MEMO

SUBJECT: 11-Lot Single Family Residential Subdivision **S15-001**
1210 N. Heather Circle – Heather Estates

PRELIMINARY PLAT

HEATHER ESTATES

PRELIMINARY PLAT

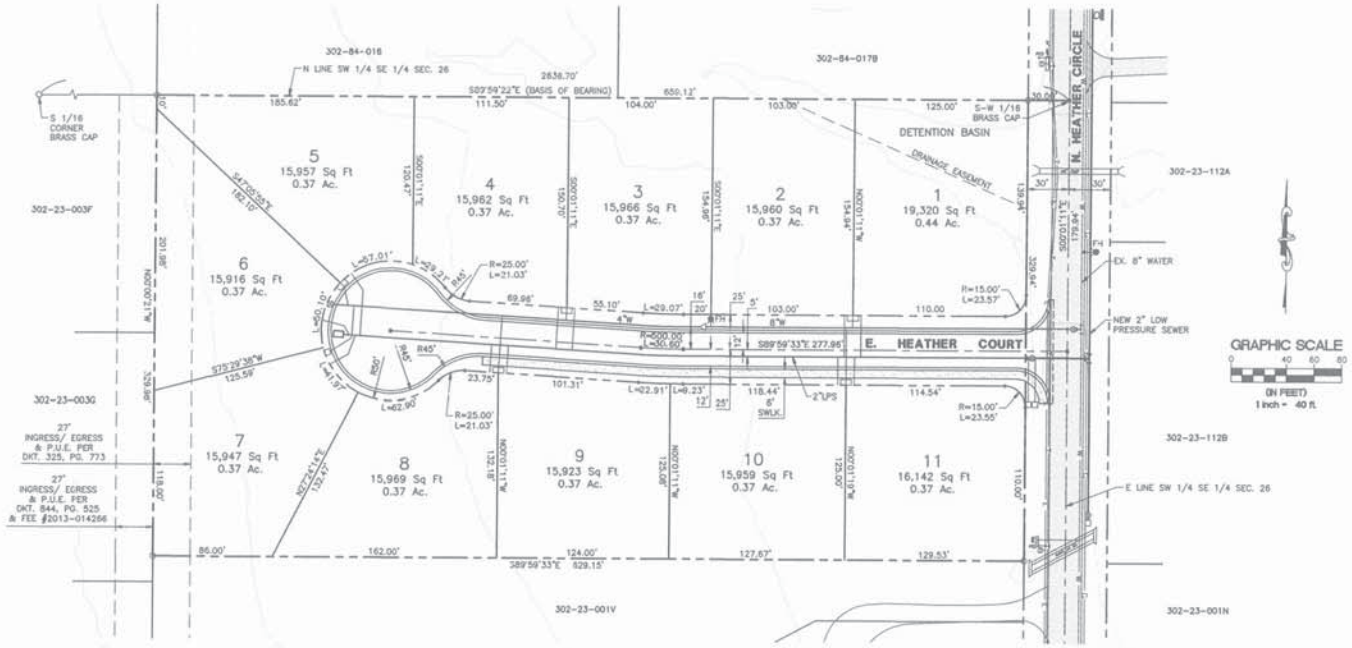
This application has been reviewed by affected Town of Payson departments and utility providers and no adverse comments have been received. This property is not within the Northern Gila County Sanitary District boundaries. All lots are required to utilize public sewer facilities. The District intends to provide public sewer to the proposed development once the property has been annexed into the District. Adequate sanitary facilities shall be designed in accordance with Northern Gila County Sanitary District standards prior to submittal of the Final Plat.

The Preliminary Drainage Report submitted has been reviewed and is feasible. A slope analysis was conducted. None of the lots shown on the preliminary plat are "Hillside" lots.

One public cul-de-sac is proposed that would provide access to interior lots within this development. The cul-de-sac improvements are being proposed with a single 6' sidewalk on one side of the roadway in lieu of a 4' wide sidewalk on both sides of the roadway, which is permissible with Commission approval.

1. The final plat shall be in substantial conformance with the preliminary plat submitted, sealed 2/13/15, and shall not exceed a total of 11 lots.
2. A final plat shall be submitted within 12 months of Planning & Zoning Commission approval of this preliminary plat.
3. The property shall be annexed into the Northern Gila County Sanitary District and shall design adequate sanitary facilities in accordance with the District standards prior to submittal of the Final Plat.
4. Storm water detention/retention shall be provided in accordance with the Town of Payson Requirements.
5. A landscape plan/tree preservation plan shall be submitted with the final plat improvement plans.
6. All other provisions of the Unified Development Code shall be met.
